10 August 2020

**SECTION 4.55(1A) MODIFICATION APPLICATION - STATE SIGNIFICANT DEVELOPMENT 7484:
SANDSTONE PRECINCT MODIFICATION 10, 23-33 & 35-59 BRIDGE STREET, SYDNEY**

Figure 1 The proposed Mod 10 changes (left) for the internal courtyard on Levels 2 through 5, and the approved Mod 7 design (right)

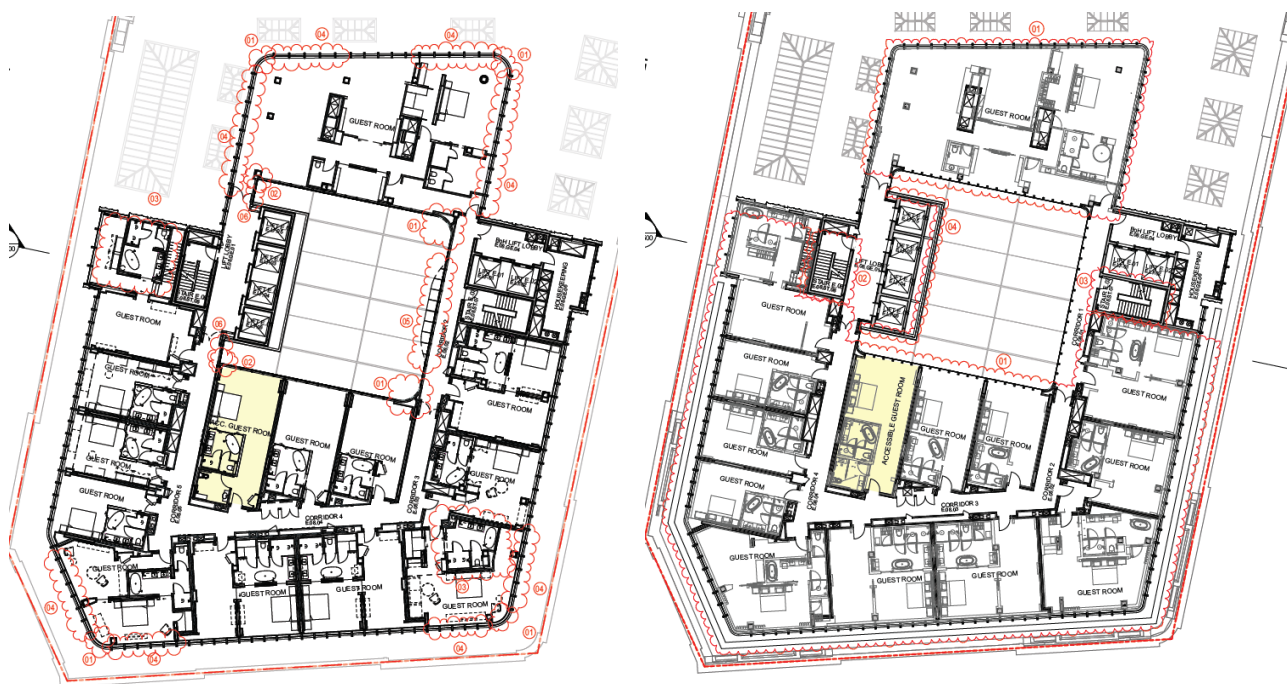
- Minor internal courtyard changes on the Education Building:
 - Changes to the radius of corner glass to 1500mm on the eastern side
 - Perforated cladding added in corner on the eastern side on Level 9

- Internal corners on western side changed from curved to square
 - Relocation of Level 9 louvres on the western side and replacement with glass spandrels

- Replaced glazed spandrel panel with perforated cladding panels and louvres (where required) from Levels 2 through 8 on western side
 - New awning hoods on Level 8, and reduction of awning hood widths on Levels 2 through 7, on the eastern side
